# SAILOR

Service Information No.  
 Kundendienst-Mitteilung No.  
 Service Information No. 61  
 Información de servicio No.  
 Servicemeddelelse No.

Supplement to point 7, Chapter C IV, Adjustment of AERIAL TUNE, LOAD and INTERNAL DRIVE in the instructionbook for T124.

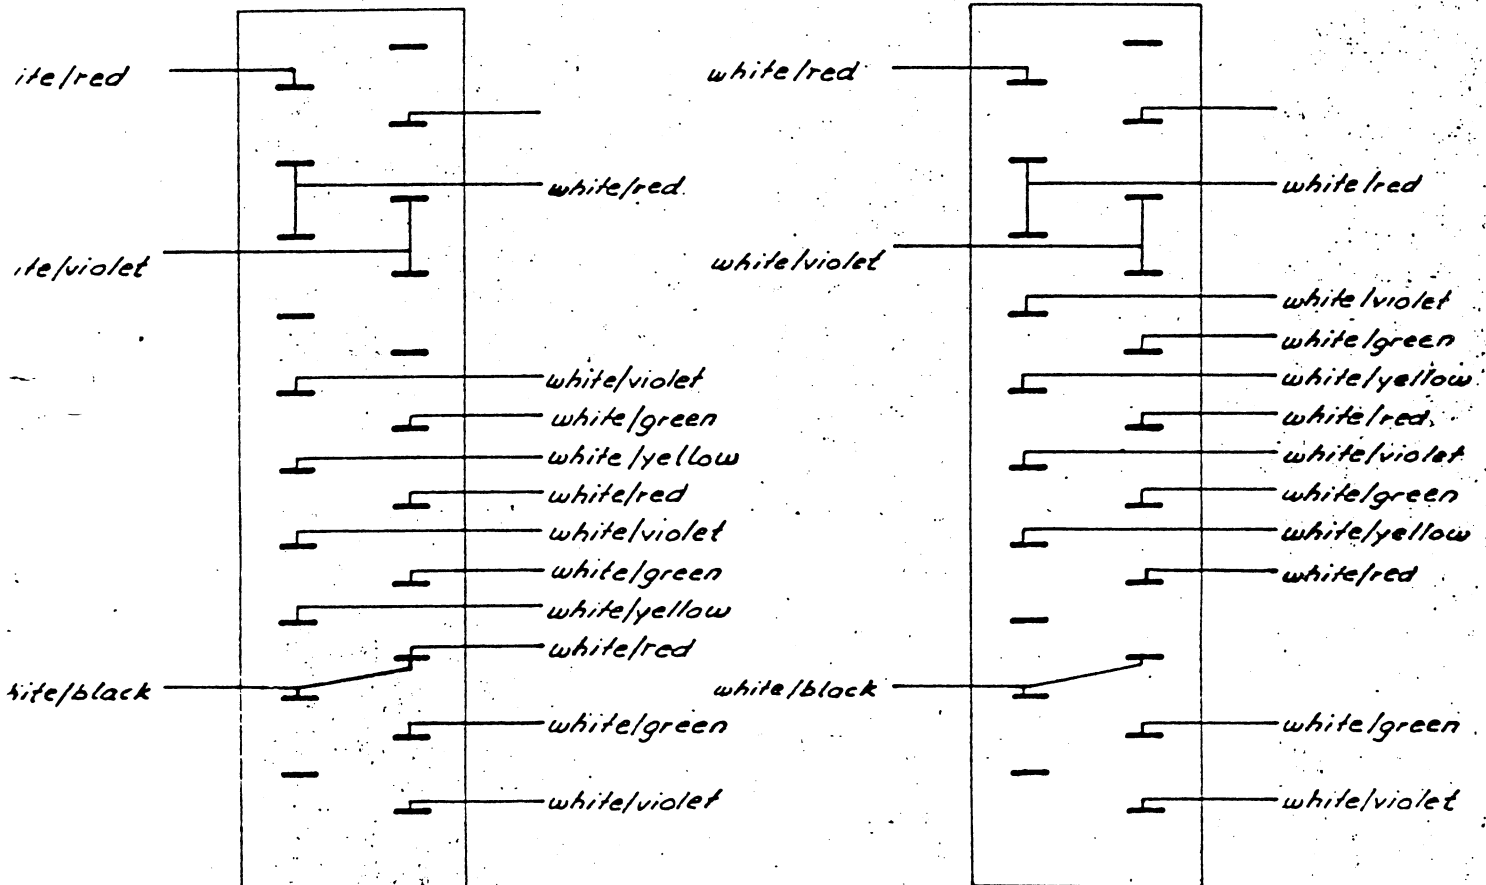
If it is not possible to bring the meter close to the zero line, like described under point 7 (the pointer of the meter is to the right of the zero line, even with contact 31 activated), this can be remedied by moving all coupling steps, 2 steps down, by soldering as shown below.

Capacitor before soldering.

Capacitor after soldering.
